Subdivision and Land Development Cover
Page for SLD # 04-23

Project Name: The Miquon School

Name of Subdivision/Land Development: The Miquon School — Heart of Campus Improvements

RE: Sketch Plan Review
2025 Harts Lane - Miquon School
Whitemarsh Township, Montgomery County, PA
S/LD # 04-23
Our Project Number 2023-03088

Drawing Title: 100 YEAR FLOODPLAIN

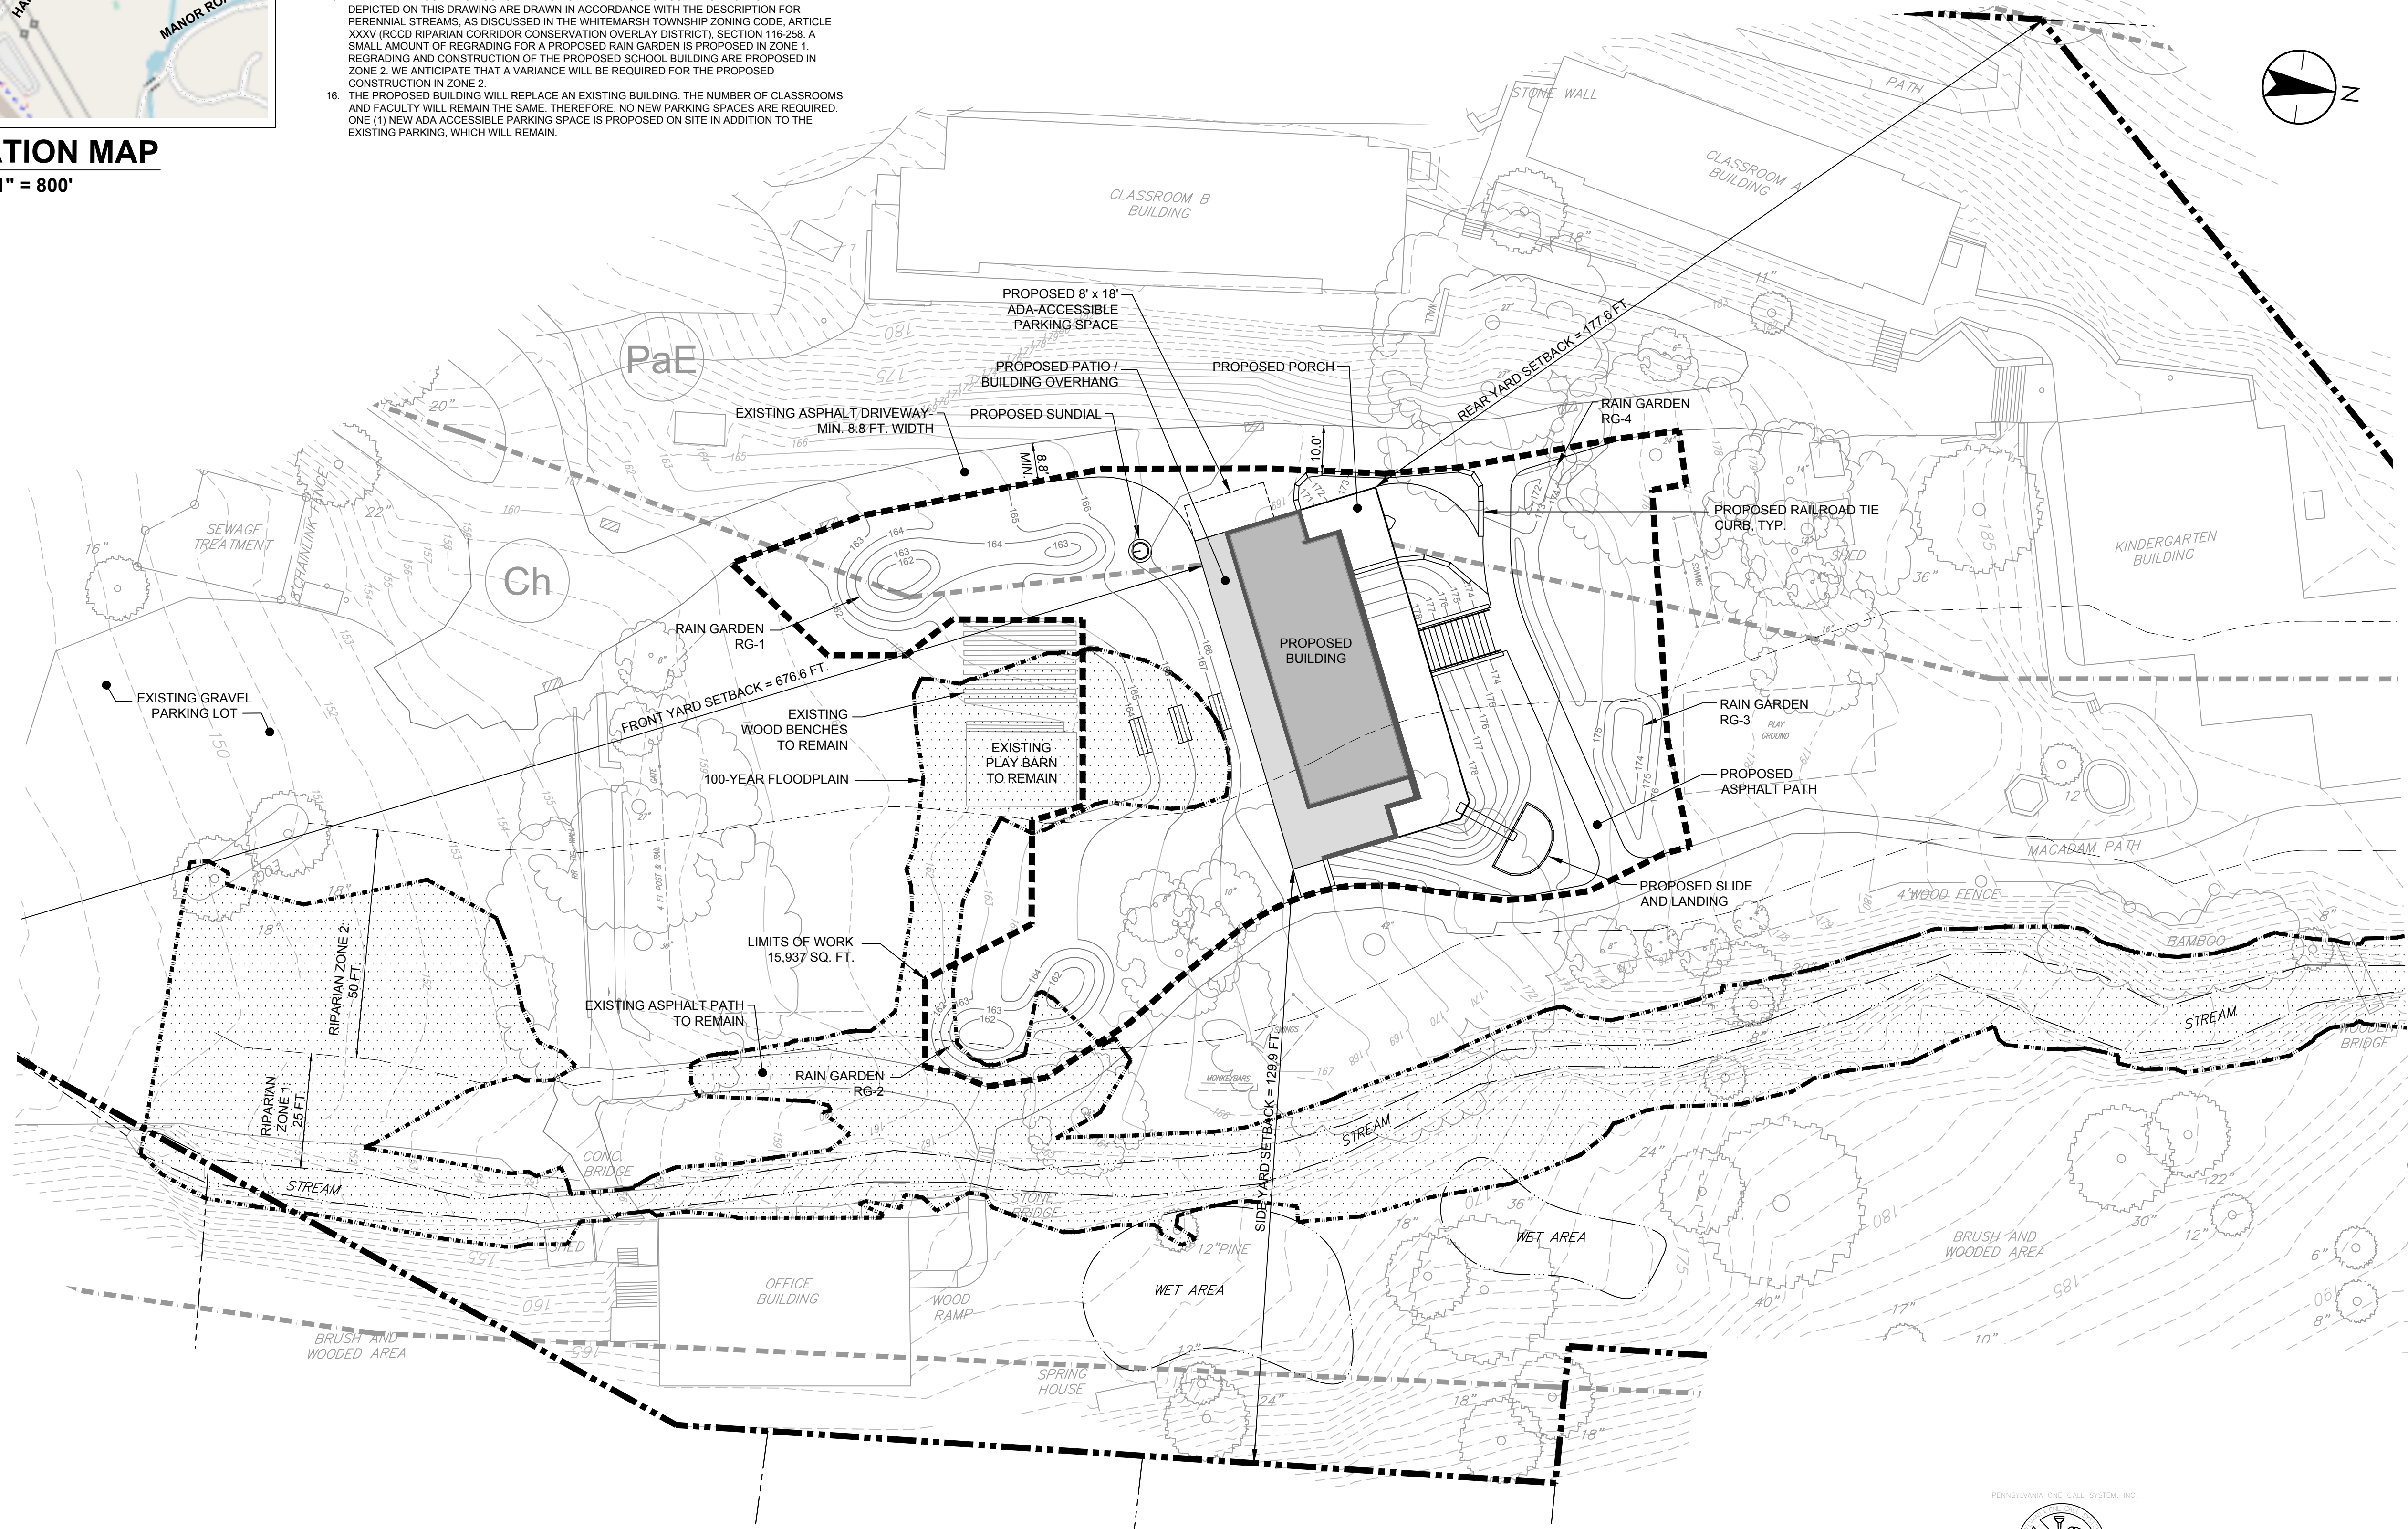
4. 105-20(B)(2), 105-20(B)(3)	The boundaries of the Floodplain Conservation District must be revised to include areas adjoining any watercourse, drainage course, or body of water, or the presence of floodplain soils, including Codorus silt loam (Ch).

Drawing Title:
RIPARIAN ZONES

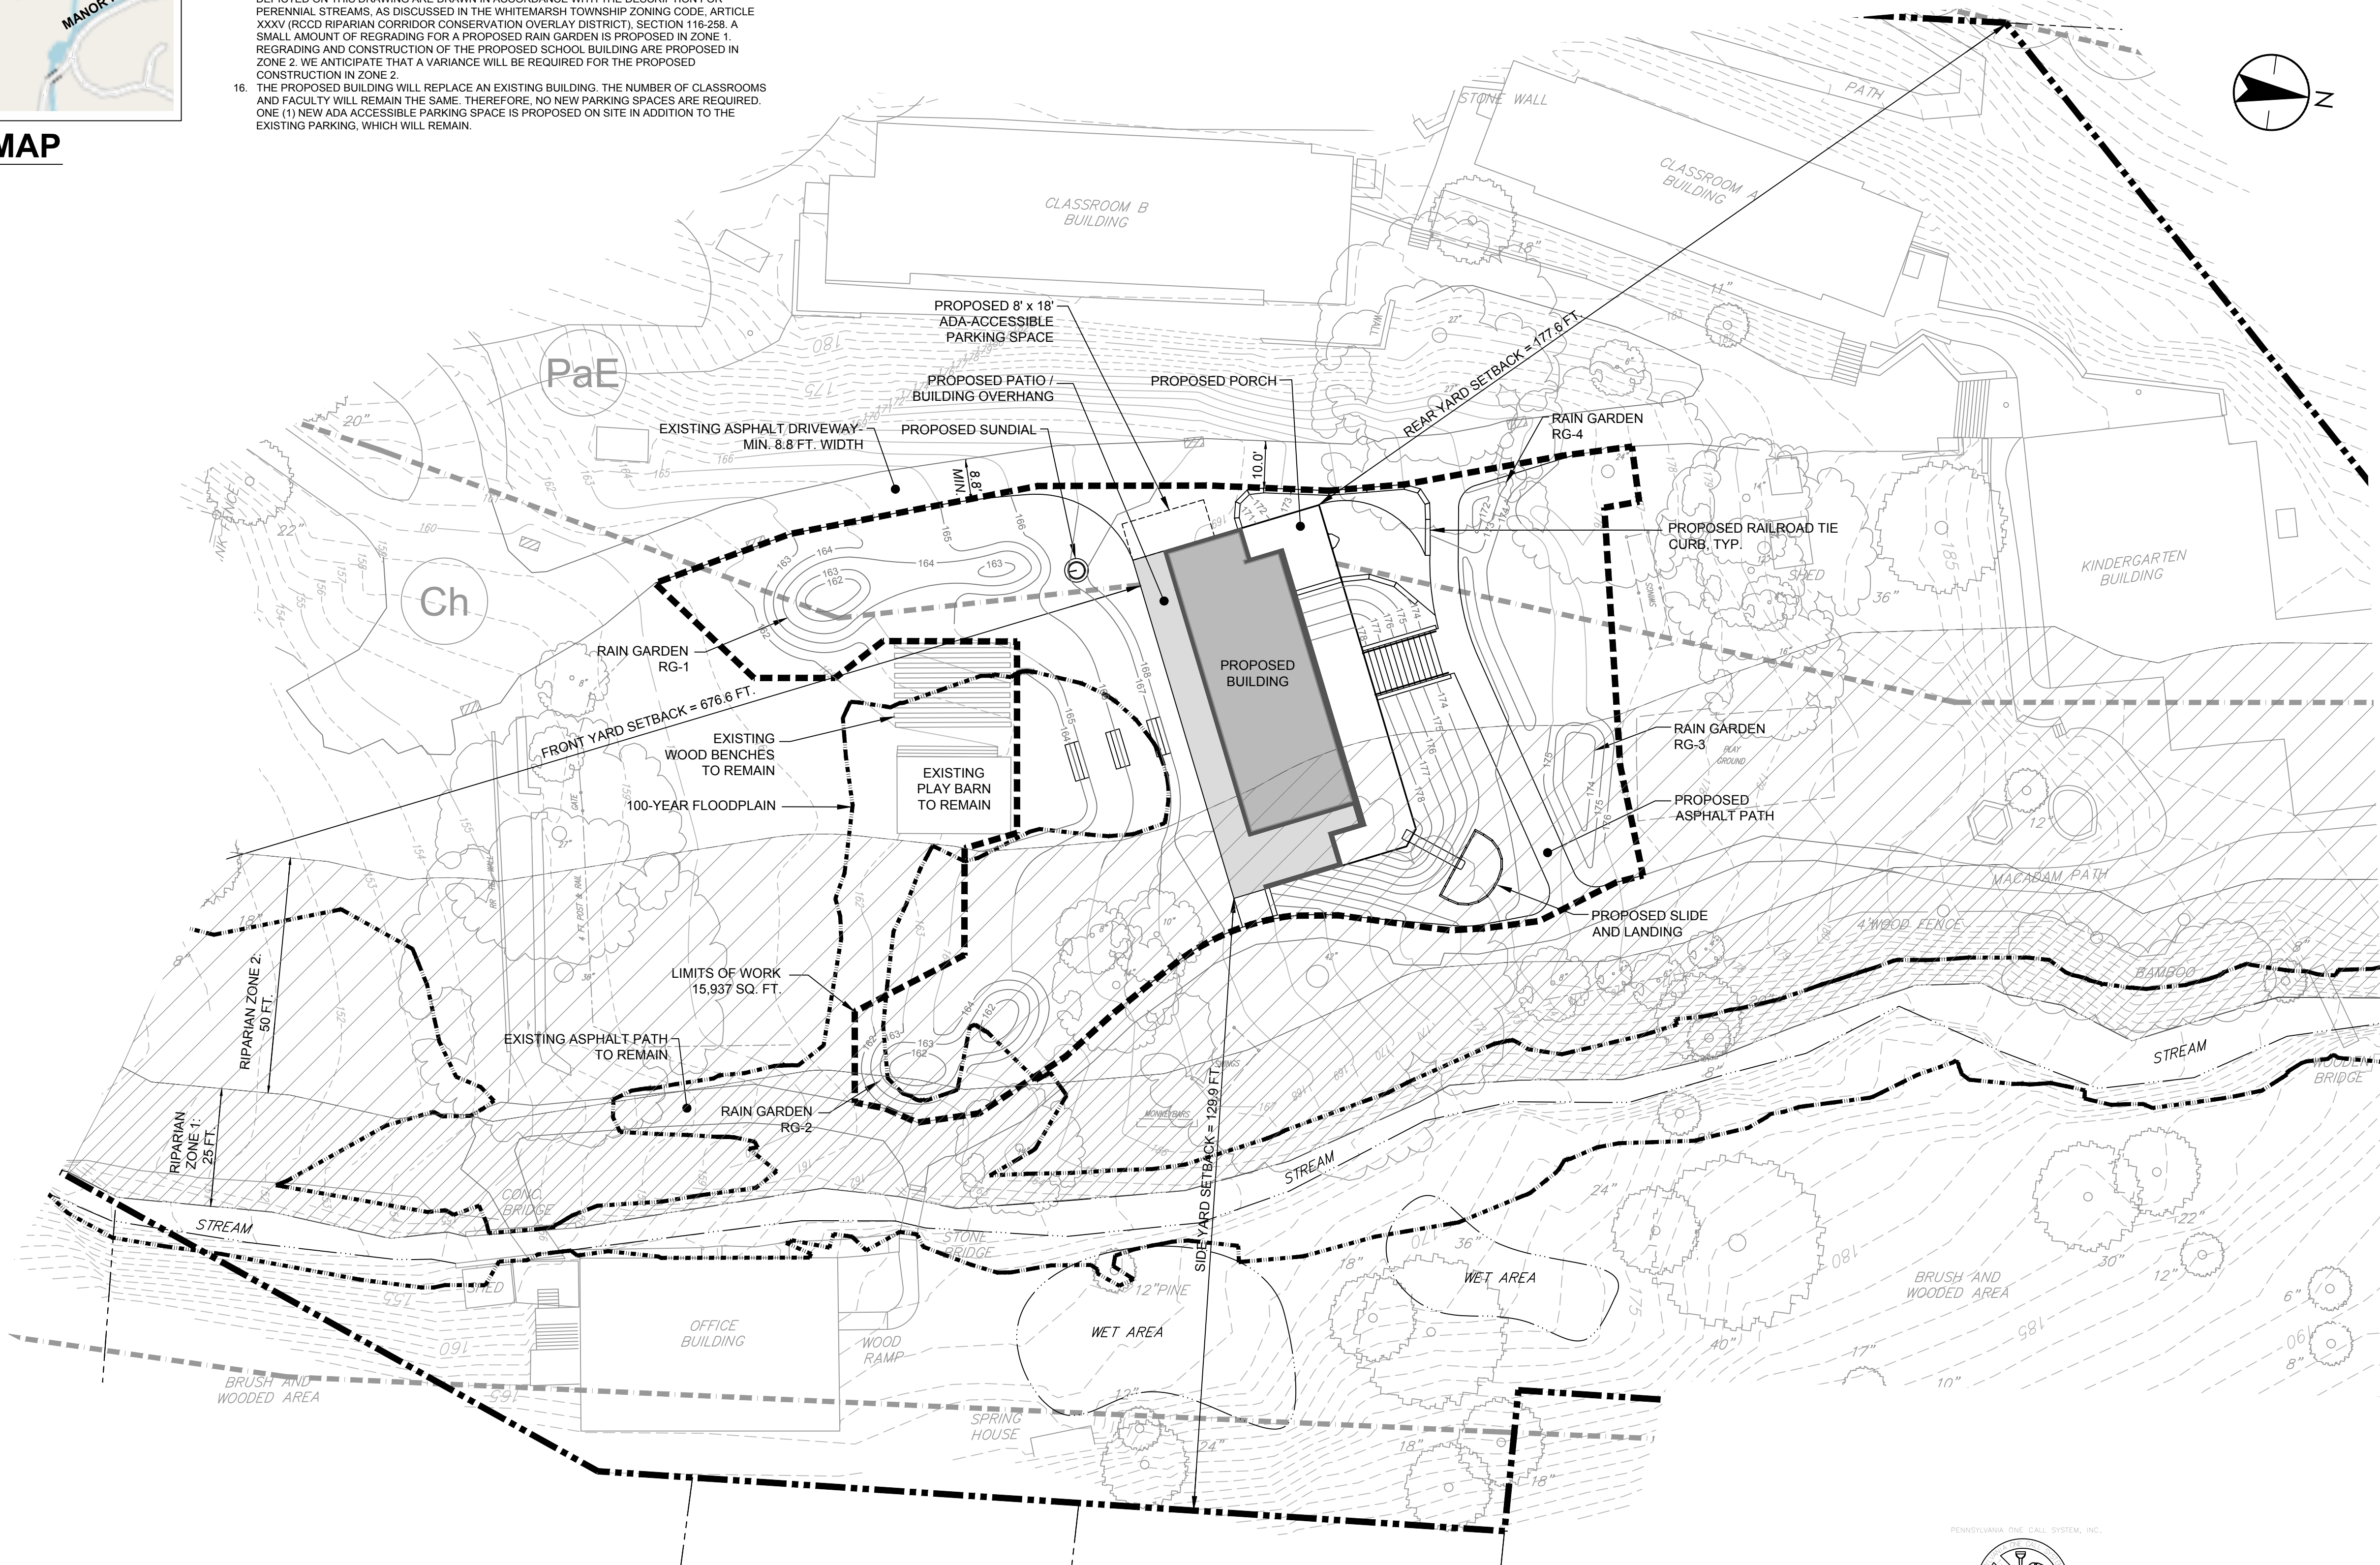
8. **§116-259.A.** This section requires that there be a setback from the Riparian Corridor Conservation Overlay District (RCCD) equal to one-half of the setback applicable on that portion of the lot (half of the applicable side yard setback in this case). Since the building is partially within Zone 2 of the RCCD, a variance from this section must be sought. (See related Comment #10.)

9. **§116-260.A.** Clearing of existing vegetation in the Riparian Corridor Conservation Overlay District is prohibited in accordance with this section. We are unable to determine whether any vegetation clearing is proposed within this area based on the submitted plans; if there is clearing proposed, a variance would have to be sought.

The sketch plan proposes the regrading and construction of the new school building in Zone 2 of the RCCD, and the regrading of a small area in Zone 1 to develop a rain garden. We acknowledge that the site is constrained with steep slopes and existing buildings that pre-date the RCCD regulations. Nonetheless, we believe that the applicant's land development plan should provide to the greatest extent feasible a robust riparian landscape buffer for the area adjacent to the perennial stream (Zone 1 & 2). An effective riparian buffer with the appropriate native plantings should be provided and is needed, given the regrading and site disturbance proposed for this area.
